Subject: <p style="text-align: center;">STAINS APPEAR ON WHEELS</p>	Bulletin No: 02-002/16
	Last Issued: 01/08/2016

Subject: POPPING AND/OR SQUEAKING NOISE FROM FRONT SHOCK ABSORBER	Bulletin No: 02-001/16
	Last Issued: 1/8/2016

- This bulletin supersedes the previous bulletin 02-004/15 issued on 05/12/15 and 04/24/15. The APPLICABLE MODEL(S)/VINS, REPAIR PROCEDURE, PART(S) INFORMATION and WARRANTY INFORMATION have been revised.
- Changes are noted below beside the change bar in Red.

A	Front Shock Absorber	C	Coil Spring
B	Mounting Rubber	D	Bump Stopper

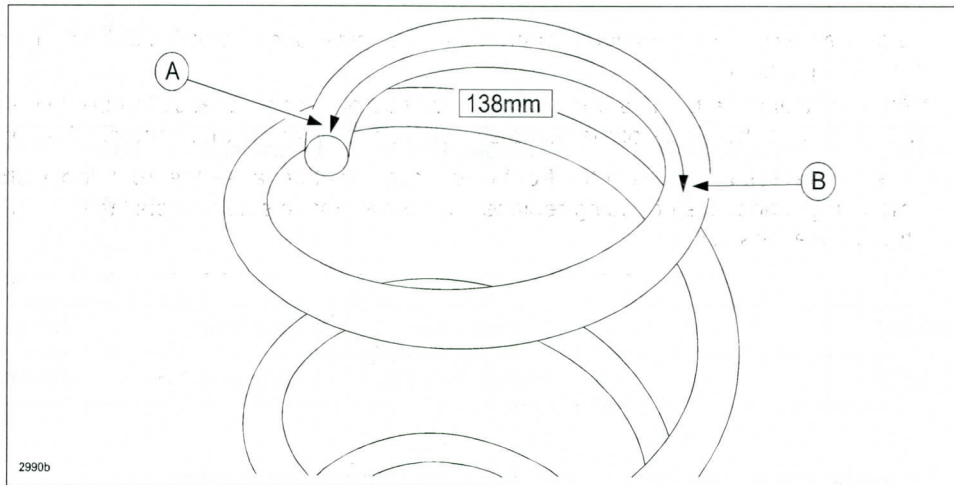
1. Verify the customer concern of noise coming from the upper part of the shock absorber when turning the steering wheel and/or driving over bumps.
2. Replace the bump stopper with the modified one according to MS3 online instructions or the Workshop Manual (section 02-13 FRONT SHOCK ABSORBER AND COIL SPRING DISASSEMBLY/ASSEMBLY).

- Before removing the mounting rubber, mark its original position so it can be re-installed later to the same position.
- When replacing the bump stopper with a modified one, apply grease to upper side of the bump stopper and to the inside of the bump stopper (on the surface that contacts the damper rod).

CAUTION: It is not necessary to adjust the front wheel alignment because the front shock absorber and mounting rubber are not being replaced. However, make sure to install the mounting rubber to the original position.

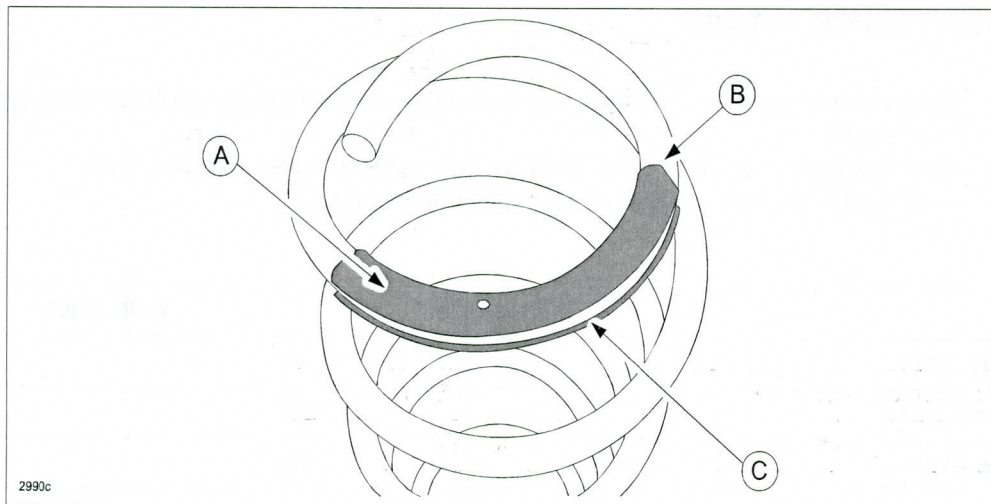
3. Install the protector (if NOT installed) onto the coil spring.
 - a. Decrease 1.5 turns of the spring from the top.
 - b. Cut a thin strip of paper to 138 mm in length (or use a cloth type measuring tape).
 - c. Place the strip of paper (or cloth measuring tape) along the inner side of the coil spring starting at point (A).
 - d. Mark the spot on the spring where (B) is. (B) is the starting point for the protector installation.

- e. Install the protector (A) onto the coil spring aligning the end (slant cut side) with the marking at spot (B).
NOTE: Install the protector so the gap (C) is evenly aligned around the outer edge of the coil spring.

- f. The inner side of the protector contains adhesive glue. After installing the protector onto the spring, press the inner side to firmly adhere it to the spring.
